DECISION OF THE PLANNING ADMINISTRATOR

TENTATIVE PARTITION PLAN CASE NO.: PAR24-04

APPLICATION NO.: 23-124791-PLN

LOCATION: 995 Fairview Avenue SE, Salem OR 97302

PARTITION TENTATIVE PLAN
995 FAIRVIEW AVE. SE
SALEM, OR 97302
TAX LOT - 073W34DD- 5200

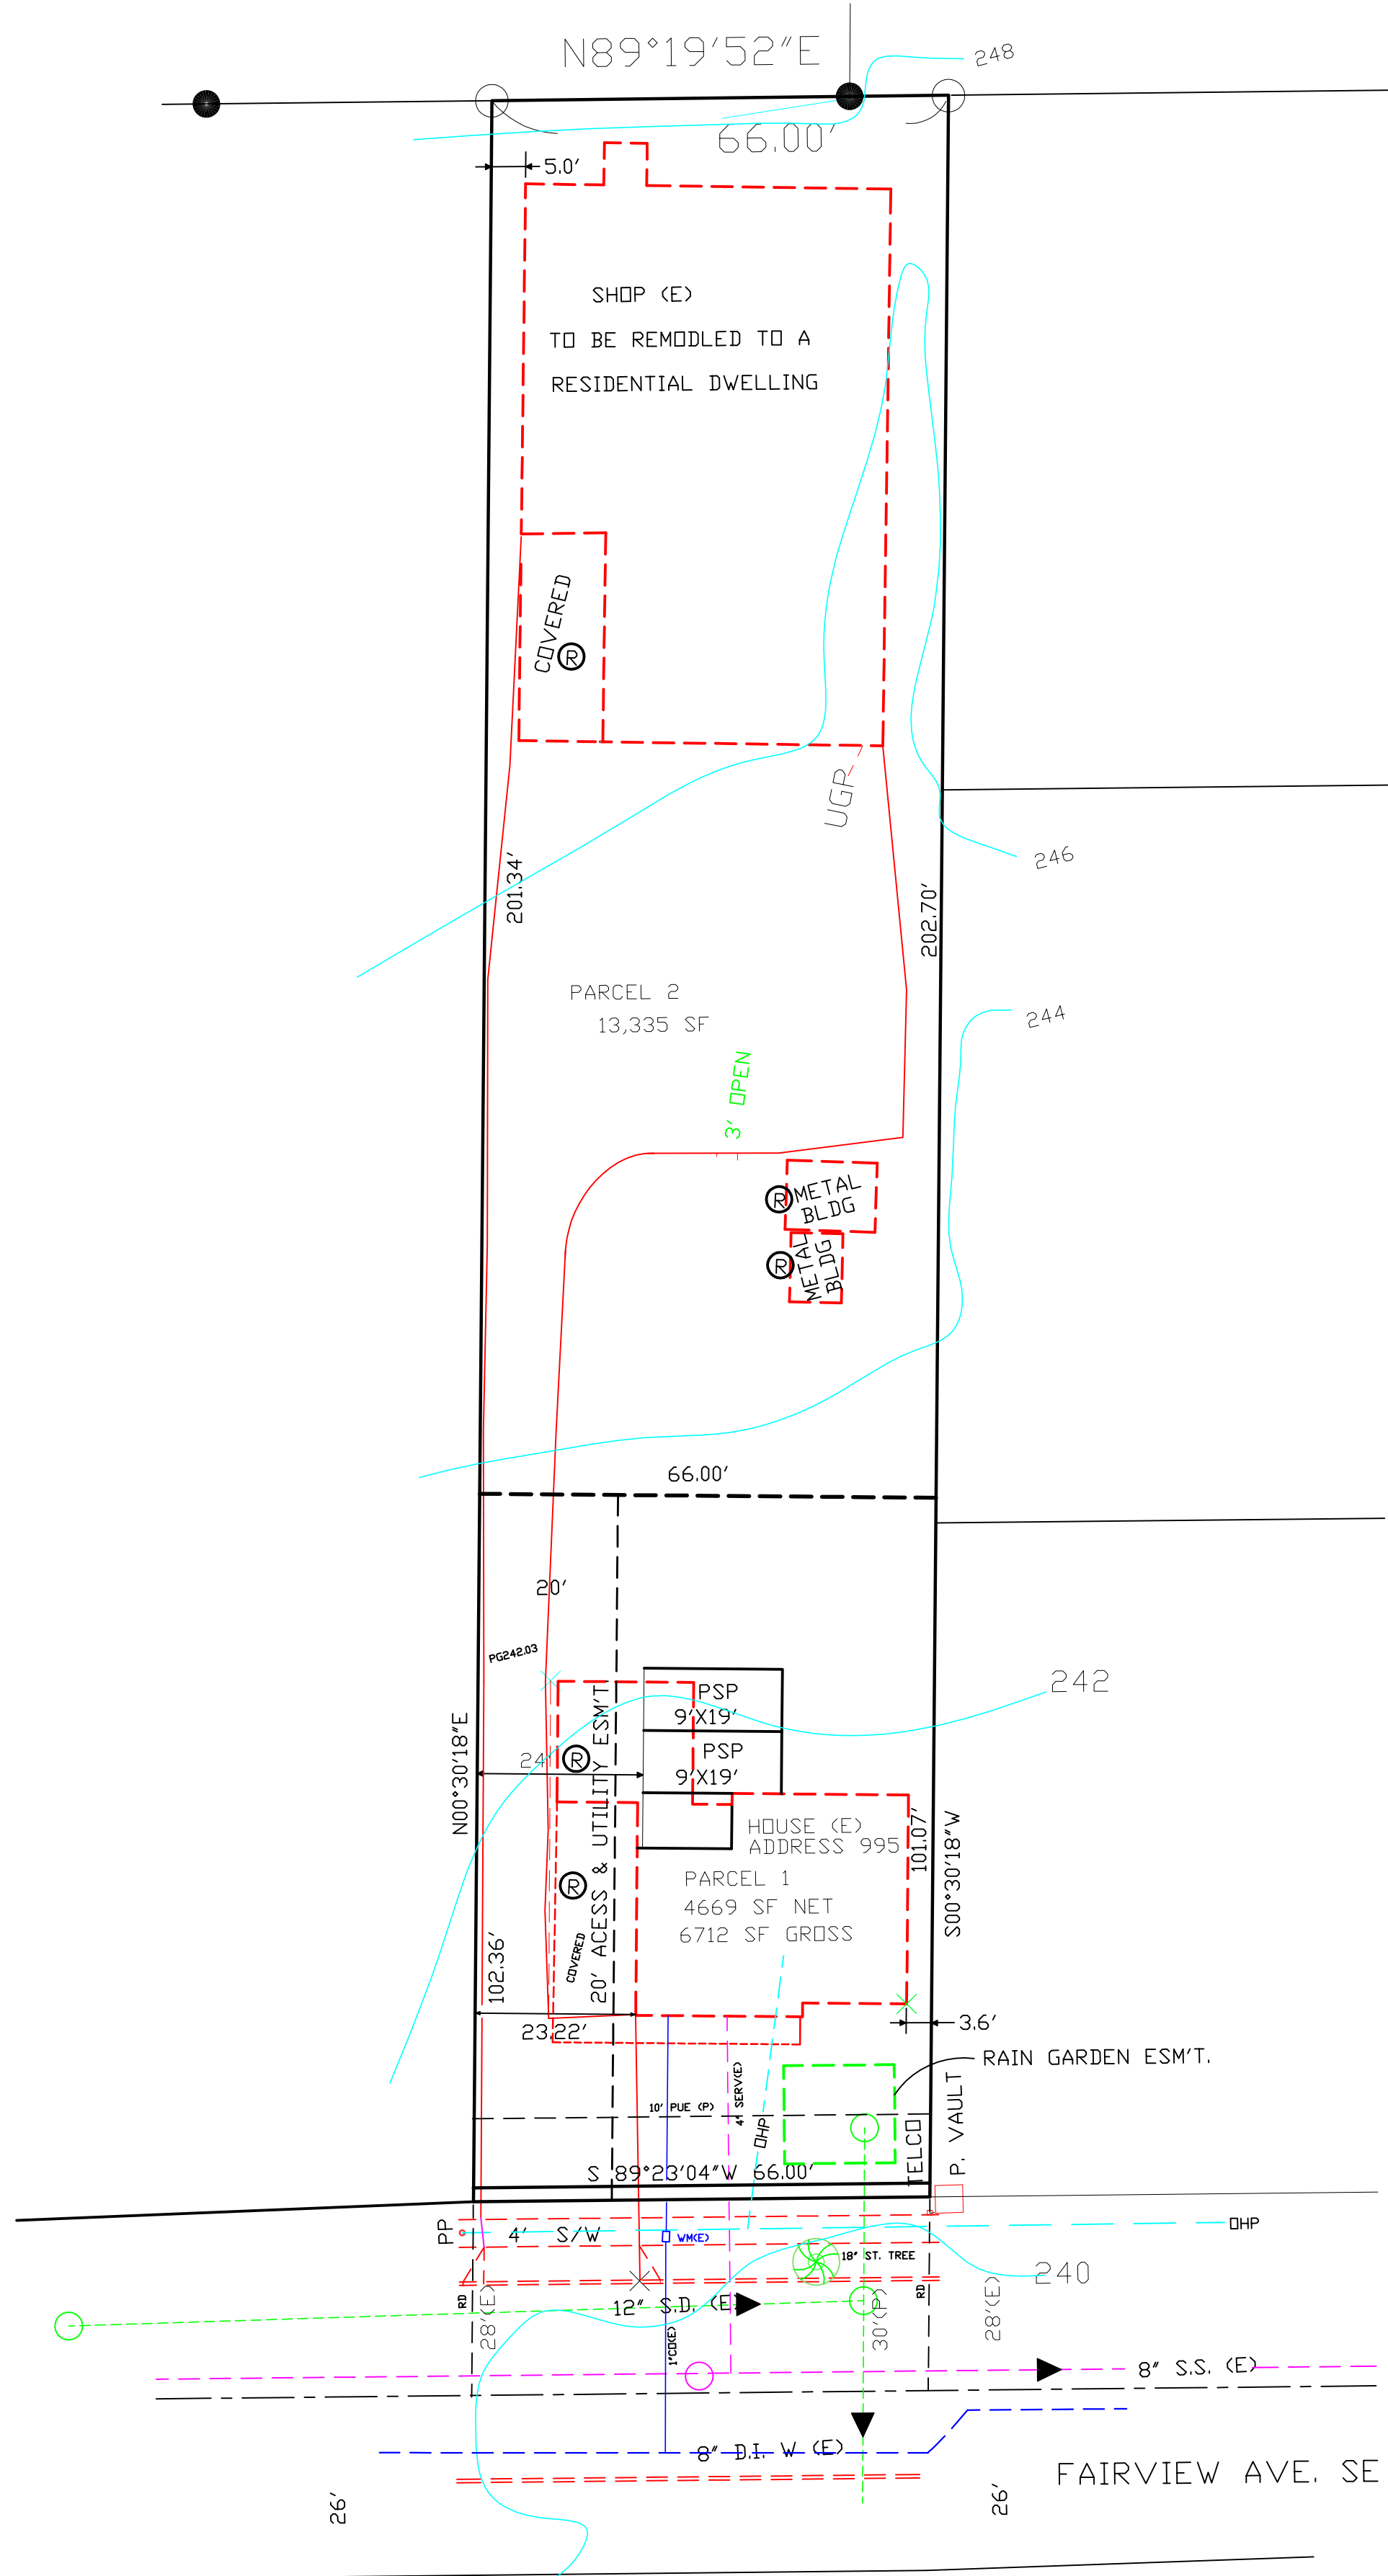
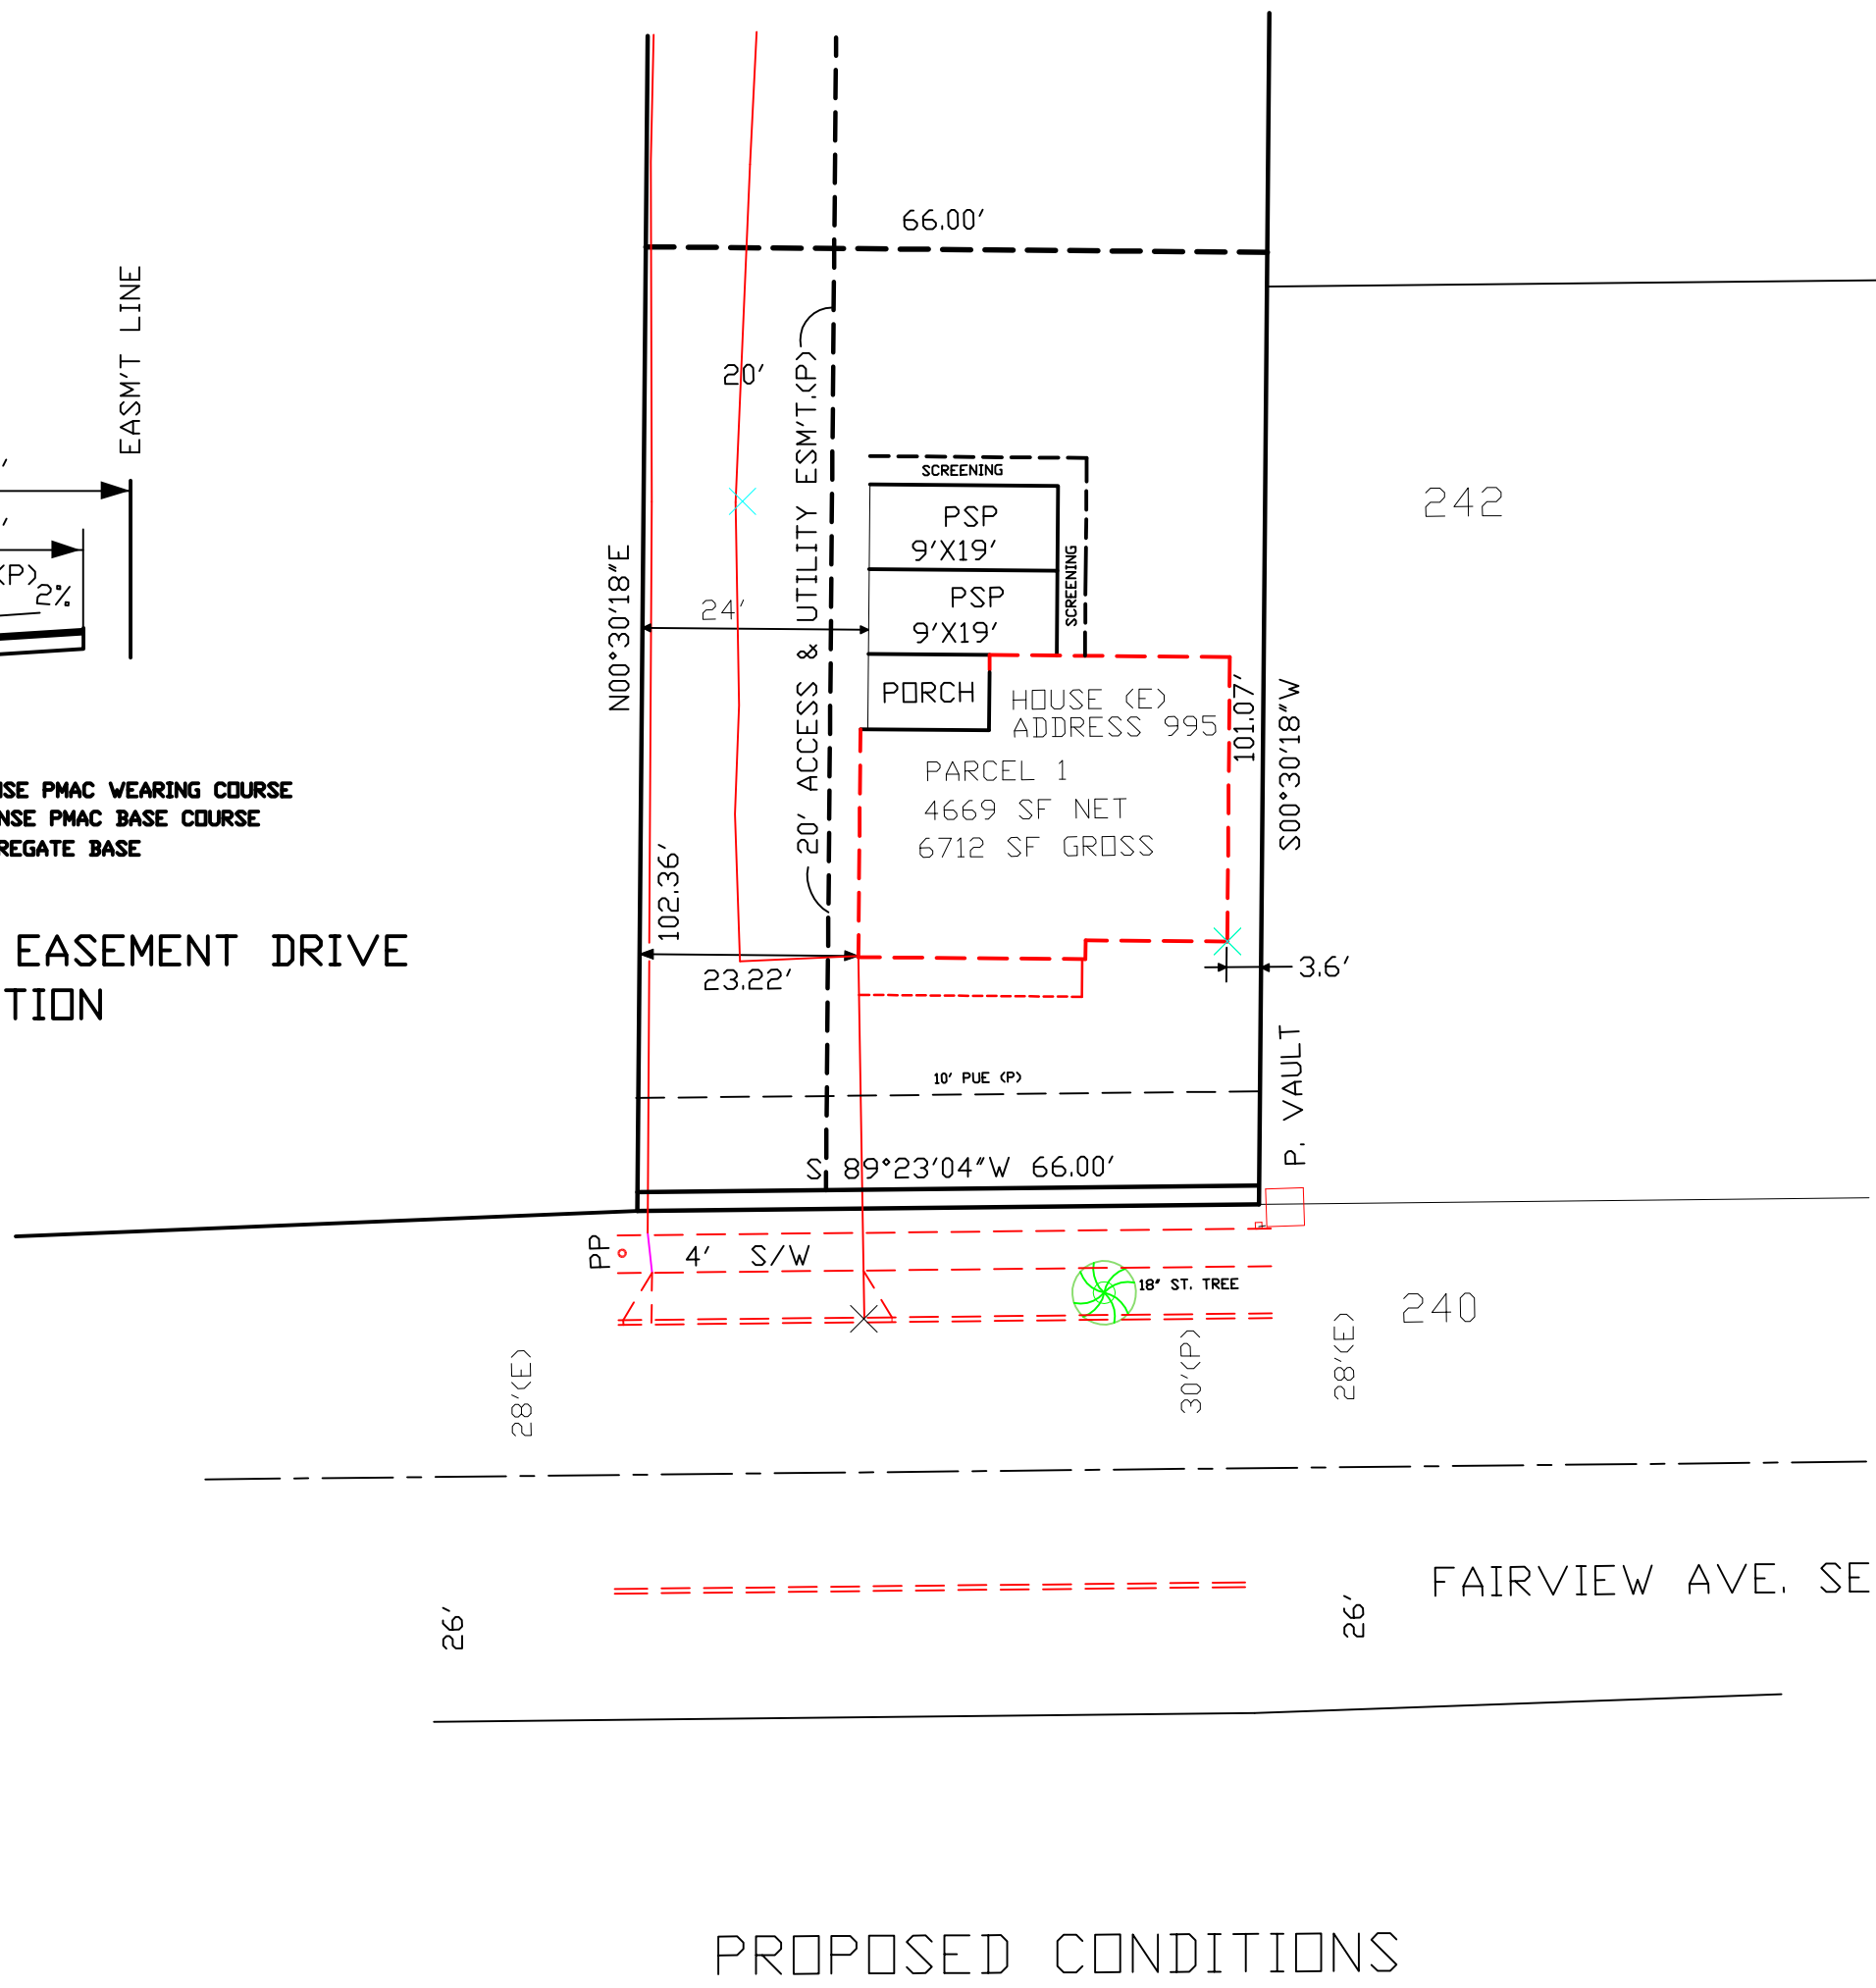
Finding: As shown on the tentative partition plan (**Attachment B**), proposed Parcel 1 is 6,712 square feet in size, or 4,575 square feet exclusive of the flag lot accessway, and will provide 46 feet of frontage on Fairview Avenue SE. Exclusive of the flag lot accessway, the proposed parcel is 46 feet in width and approximately 100 feet in depth after right-of-way dedication. Therefore, Parcel 1 meets the area, width, depth, and frontage lot standards. Proposed Parcel 2 is 13,335 square feet in size, and will provide 20 feet of frontage on Fairview Avenue SE via the flag lot accessway, which is the minimum required for a flag lot serving one-to-two dwelling units, per SRC 800.025. The proposed parcel is 66 feet in width and approximately 202 feet in depth. Therefore, Parcel 2 meets the area, width, depth, and frontage lot standards.

Finding: The existing single-family dwelling, which would remain on proposed Parcel 1, currently has a carport and storage area structure along that west side of the house that would encroach into the required flag lot accessway. Pursuant to SRC 112.050(c)(2), setbacks abutting a flag lot accessway shall be measured from the most interior access easement line, if an access easement exists. The applicant proposes to remodel the existing residence to remove the carport and storage portion of the house to comply with the minimum three-foot setback applicable to existing buildings abutting the new flag lot

Finding: The applicant’s partition plan indicates the proposed flag lot accessway is approximately 100 feet in length after right-of-way dedication, 20 feet in width, which could serve a maximum of two dwelling units. The plan does not indicate the minimum 15-foot-wide required paved accessway, per SRC 800.025, Table 800-1. To ensure conformance with the standards, the following conditions shall apply.

Any easements needed to serve the proposed parcels with City infrastructure shall be shown on the final plat. The proposed partition plan shows a 20-foot access and utility easement to serve Parcel 2. The proposed partition plan also shows the stormwater facility located on Parcel 1 for the total new impervious surface for Parcel 2 and the access for Parcel 2 that is located on Parcel 1; a storm drainage easement is required for the proposed shared facility.

- Condition 1:** Prior to final plat approval, obtain a demolition permit to remove the existing carport and portions of the house on the west side of existing residence on Parcel 1 that will provide at least a three-foot setback along the proposed flag lot accessway.

Condition 3: The proposed property served by the flag lot accessway, Parcel 2, shall be limited to a maximum of two dwelling units.

Condition 4: At the time of building permit review, the applicant shall pave the required minimum 15 feet within the 20-foot-wide flag lot accessway with a hard surface material.

Condition 5: At the time of building permit review, the applicant shall install “NO PARKING” signs on both sides of the flag lot accessway.
